Access Compliance Report

Public Rights-of-Way

Intersection ID: 3840	Main Street: CHIMNEY RIDGE TL	Cross Street: DEER CROSS TL	Location:	NW
ADA ID: 6E20DCDA5521	Ramp Type: Perp	Initial Pass/Fail: Fail	Overall Compliance: No	Severity Score: 10

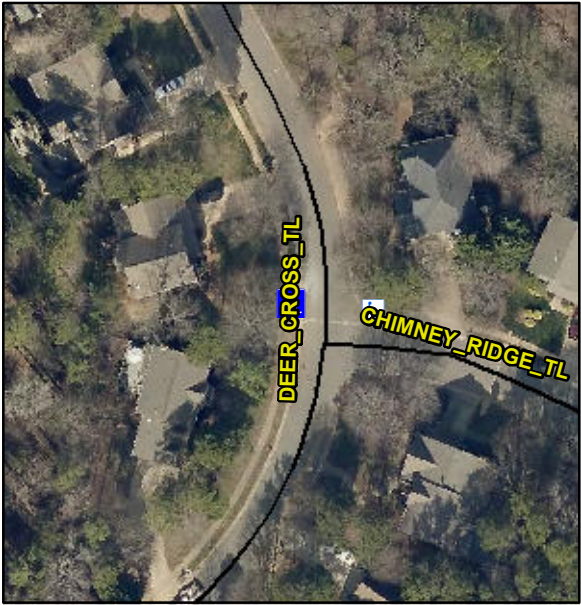
Codes/Mitigation Info/Possible Solution			Field Measurements/Component Compliance		
	Possible Solutions:		Compliance	Description	Data
	Remove & Replace Entire Ramp.		Yes	Ramp Slope (%)	6.1
			No	Ramp XSlope (%)	3.9
			N/A	Flare Type LT	N/A
			N/A	Flare Slope LT (%)	N/A
			N/A	Flare Traversable LT?	N/A
			N/A	Flare Traversable RT?	N/A
			N/A	DWS Provided?	N/A
			N/A	DWS Contrast?	N/A
			N/A	DWS Length (in)	N/A
<p>Surveyor Notes:</p> <p>N/A</p> <p>PROW/ADA:</p> <p>Not Found, R304.5.1, R304.5.3</p>			N/A	DWS Full Width?	N/A
			N/A	DWS Offset (in)	N/A
			N/A	Shared Landing?	N/A
			N/A	Gutter Ponding?	N/A
			N/A	Gutter Lip Ht (in)	N/A
			N/A	Painted X Walk1?	N/A
			N/A	X Walk 1 Direction	N/A
			N/A	X Walk 1 Width (in)	N/A
			N/A	X Walk 1 Slope (%)	N/A
			N/A	X Walk 1 X Slope (%)	N/A
<p>Total Cost:</p> <p>\$ 1850.00</p>			No	Painted X Walk2?	N/A
			To E	X Walk 2 Direction	N/A
			N/A	X Walk 2 Width (in)	N/A

5.2	X Walk 2 Slope (%)	N/A
			3.4	X Walk 2 X Slope (%)	N/A
			N/A	Ramp inside XWalk1?	N/A
			N/A	Ramp inside XWalk2?	N/A
			N/A	Road Slope (%)	N/A
			N/A	Road X Slope (%)	N/A
			N/A	Any Obstructions?	N/A
			N/A	Obstruction Type	N/A
			N/A	Storm Grate/Utility Hazard?	N/A
			N/A	Storm Grate/Utility Type	N/A
			N/A	Surface Condition? (G/P)	Good
			N/A		
			N/A		
			N/A		
			N/A		
			N/A		
			N/A
